## PRODUCT CHANGE NOTICE

**PCN#23-021**

**ZX60-P162LN+**

Change of Case Style GC957 to GC957-2

## GC957-2

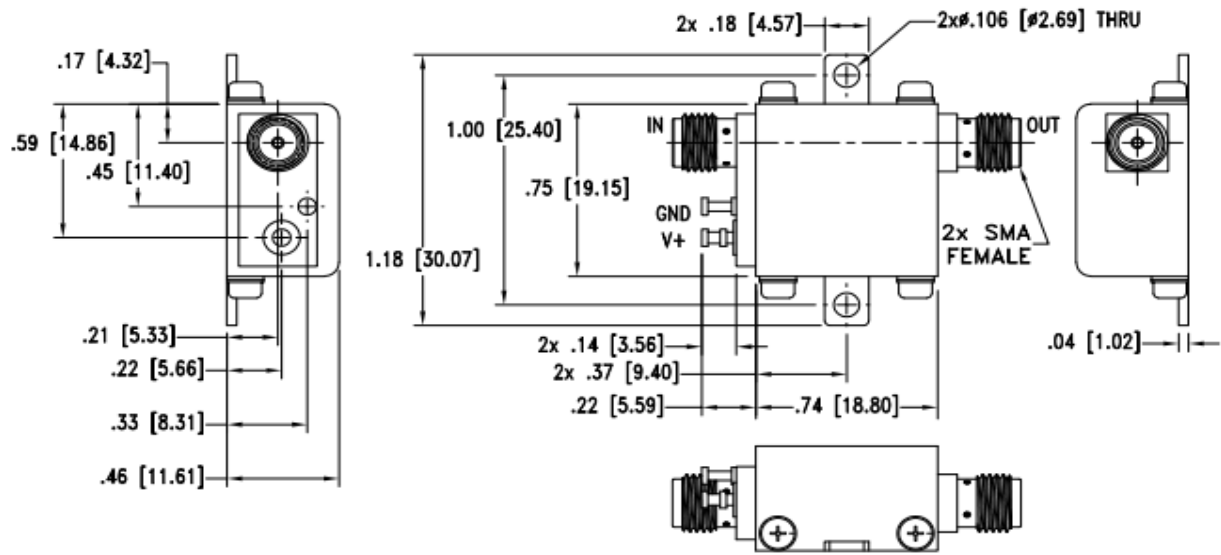
Clarification of the outline drawing to make it in accordance with the actual units' performance and physical outline
